Cundy Street Quarter

# Design and Access Statement Addendum

October 2020

### Ground Floor Plan - Additional Detail and Minor Amendments

### 3. Building B : Bike Store

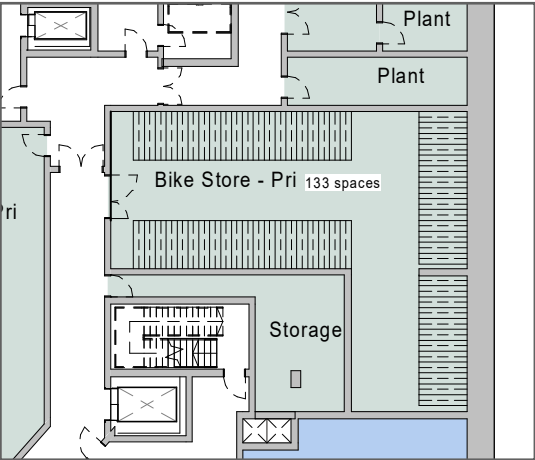
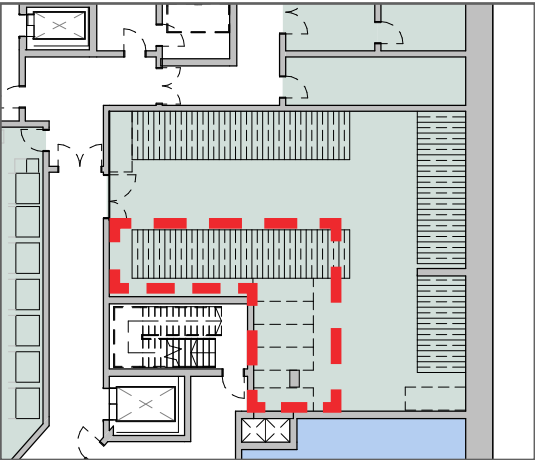
Minor amendments to internal cycle store layout in response to GLA comments for cycle spaces to comply with TfL London's Cycling Design Standards. As a result, more cycle racks and space for larger bikes are now provided.

### 4. Building B : Refuse Store

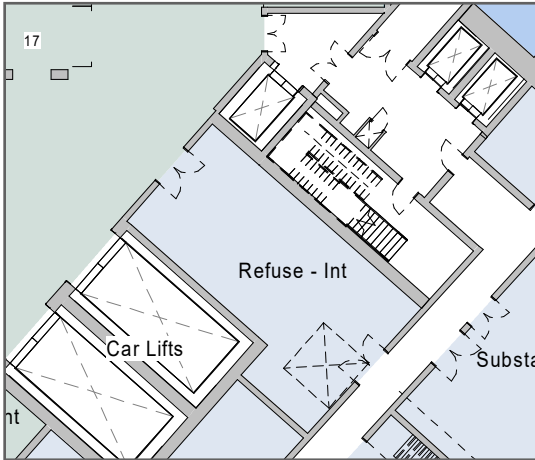
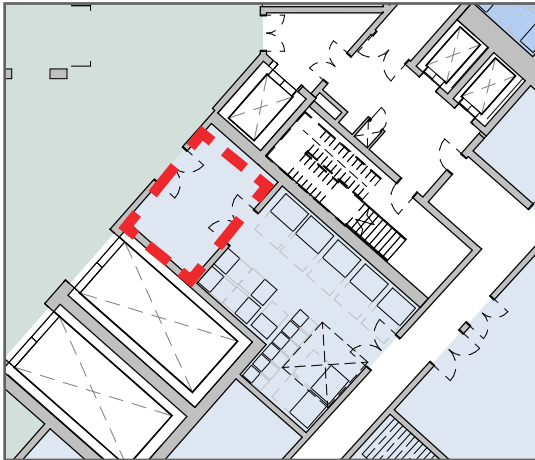
Following consultation with WCC's Waste Officer, a designated temporary holding area within Building B's Intermediate Tenure has been proposed to host 'bulky storage'.

### 5. Building C : Bike Store

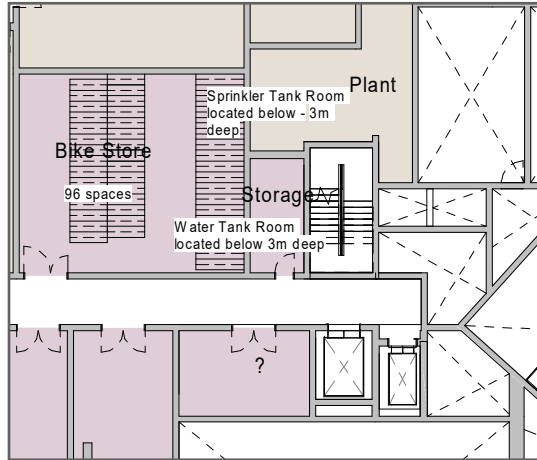
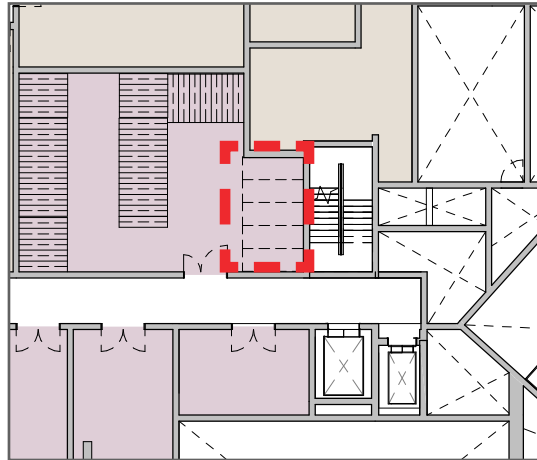
Minor amendments to internal cycle store layout in response to GLA comments for cycle spaces to comply with TfL London's Cycling Design Standards. As a result, space for larger bikes is now provided.
